SUBJECT: Request for Additional Information Regarding
Extended Power Uprate
Grand Gulf Nuclear Station, Unit 1
Docket No. 50-416
License No. NPF-29

Grand Gulf Nuclear Station Extended Power Uprate

Response to Request for Additional Information

Containment and Ventilation Branch

MISSISSIPPI POWER & LIGHT COMPANY GRAND GULF NUCLEAR STATION UNITS 1 & 2 UPDATED FINAL SAFETY ANALYSIS REPORT	PRESSURE RESPONSE FOR RECIRCULATION LINE BREAK FIGURE 6.2-2
--	--

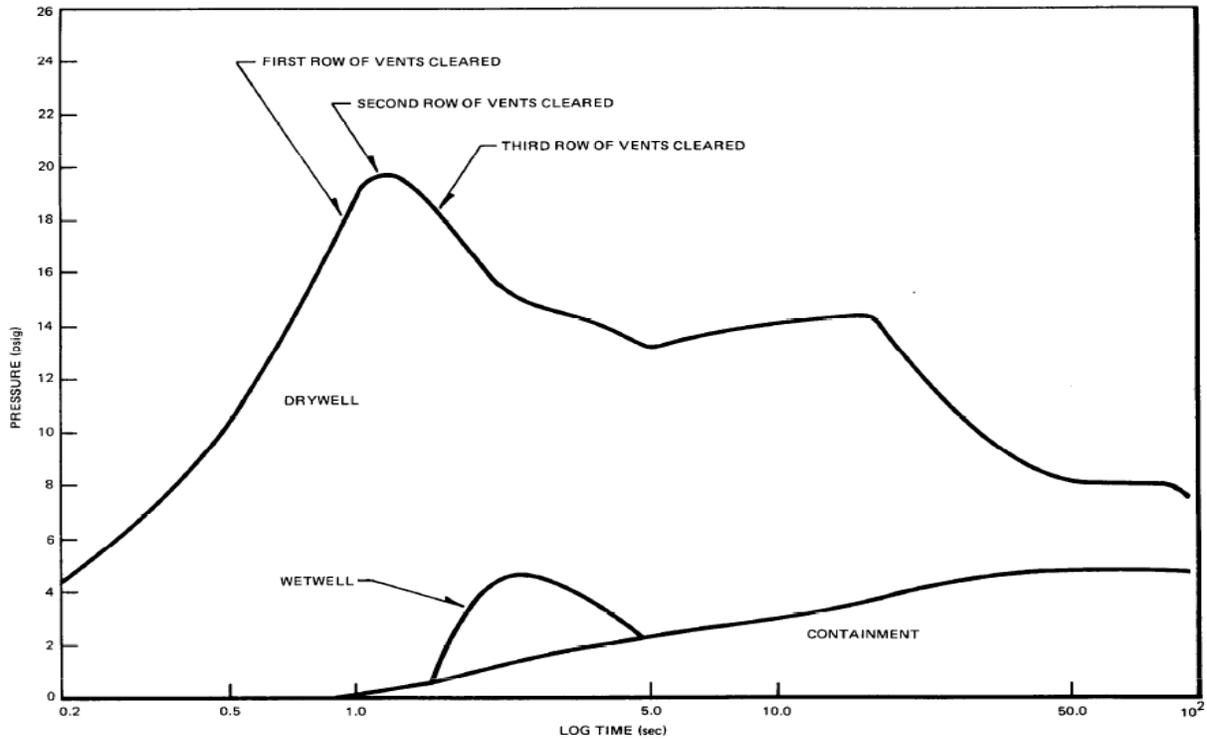
Refer to Entergy's response to RAI # 25 in letter dated March 31, 2011 (ML110900586 and ML110900593). Provide a pressure and temperature profile for the containment analysis that resulted in the limiting peak pressure of 11.9 psig given in PUSAR Table 2.6-1 that Entergy proposes to use as 'P_a' for the 10 CFR 50 Appendix J integrated leak rate testing (ILRT). Provide a detailed discussion explaining why the short term peak pressure of 14.8 psig (given in PUSAR Table 2.6-1) should not be used as 'P_a'. In the discussion, include similar precedent Mark III containment examples that have been approved by NRC. Please note that in the current licensing basis the long term peak pressure of 11.5 psig (PUSAR Table 6.2-1) being greater than the short term peak pressure of 9.9 psig approximately (extracted from UFSAR Figure 6.2-10) justifies the current TS value of 'P_a' as 11.5 psig. Also note that the definition of 'P_a' given in 10 CFR Appendix J under "II Explanation of Terms" item I is: "Pa (p.s.i.g.) means the calculated peak containment internal pressure related to the design basis accident and specified either in the technical specification or associated bases."

The GGNS containment analyses are described in Section 6.2 of the Update Final Safety Analysis Report (UFSAR) and address the recirculation line break and the main steam line break (MSLB). The short-term pressure results in UFSAR Figures 6.2-2 and 6.2-10 (provided below) both indicate a short-term pressurization of the area under the Hydraulic Control Unit (HCU) floor defined in the figures as the "wetwell." This short pressurization appears to be worse for the MSLB where it reaches a pressure of approximately 9 psig before equilibrating back to the bulk containment pressure within the first 5 seconds of the accident. In all cases, this short-term pressurization is less than the long-term peak pressure of 11.5 psig which occurs in about 3.5 hours with minimum emergency core cooling system (ECCS) per UFSAR Figure 6.2-5 (provided below). Long-term peak pressure includes feedwater mass addition per UFSAR
